**PROPOSAL: PROPOSED LOFT
CONVERSION WITH GABLE / REAR
FLAT ROOF DORMER; FORMING
BEDROOM.**

PROPOSED PART SITE PLAN.

PAPER	SCALE	DATE	DRAWING No	REV
A3	1:100	10/25	M4632/04/101	A

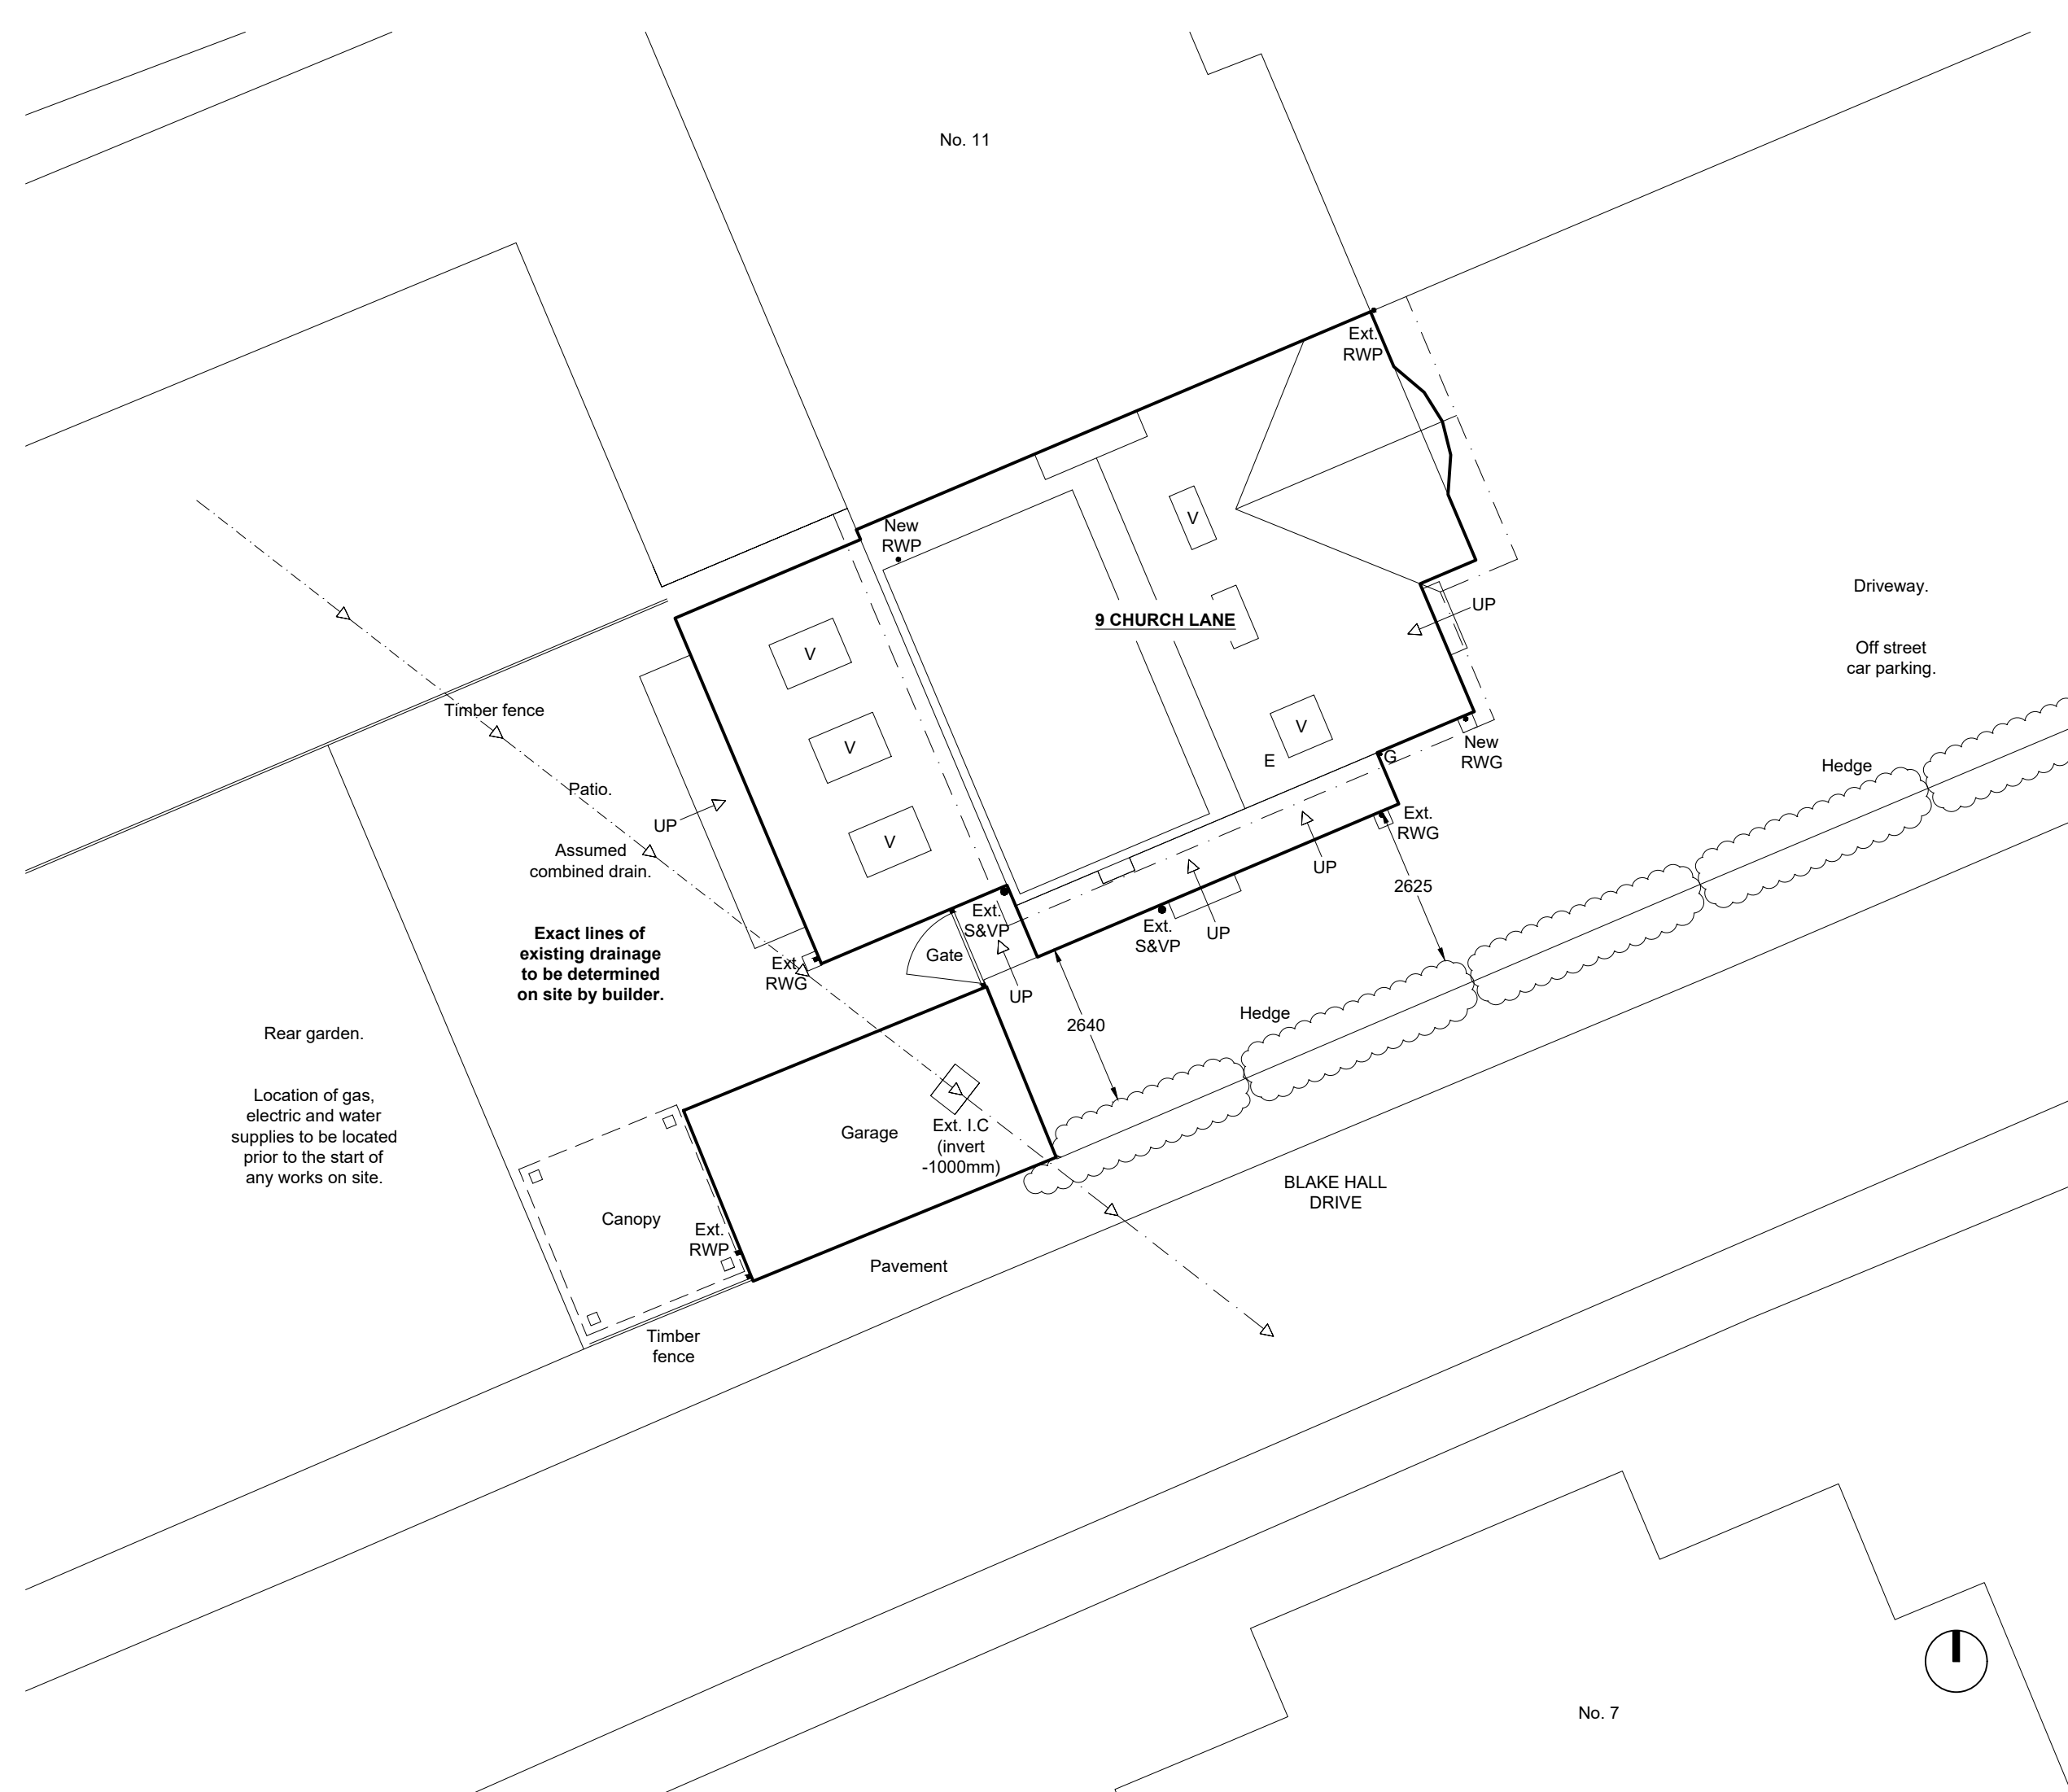
Rev.A Reverted new S&VP to ext. S&VP 23.03.26
to suit Planning Officers comments.
